PCN #: 2374 Rev 2

PCN Title: Qualification of "Diodes Technology (Cheng Du) Company Limited" (CAT) as an Additional Assembly & Test Site, Conversion to Palladium Coated Copper Bond Wire with New Molding Compound, and Qualification of Alternative Die Source on Select Products

PRODUCT CHANGE NOTICE

Table 8 - Mark Code Format – DFN2020

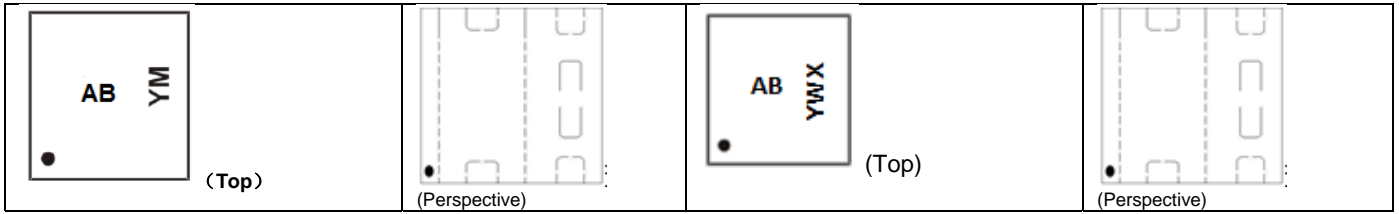
SAT (Diodes Internal AT site Shanghai, China)		CAT (Diodes Internal AT Site Chengdu, China) Change from YM to YWX for CAT site	
Marking orientation photo(PlanForm,Perspective,from top to bottom)		Marking orientation photo(PlanForm,Perspective -from top to bottom)	
1.DFN2020-2		1.DFN2020-2	
 (Top)	 (Perspective)	 (Top)	 (Perspective)
2.DFN2020B-6		2.DFN2020B-6	
 (Top)	 (Perspective)	 (Top)	 (Perspective)
3. DFN2020E-6		3. DFN2020E-6	
 (Top)	 (Perspective)	 (Top)	 (Perspective)
4.DFN2020F-6		4.DFN2020F-6	
 (Top)	 (Perspective)	 (Top)	 (Perspective)
5.DFN2020H4-6		5.DFN2020H4-6	
 (Top)	 (Perspective)	 (Top)	 (Perspective)
6. DFN2020W-6		6. DFN2020W-6	
 (Top)	 (Perspective)	 (Top)	 (Perspective)
7.SWP-DFN2020E-6		7.SWP-DFN2020E-6	
 (Top)	 (Perspective)	 (Top)	 (Perspective)
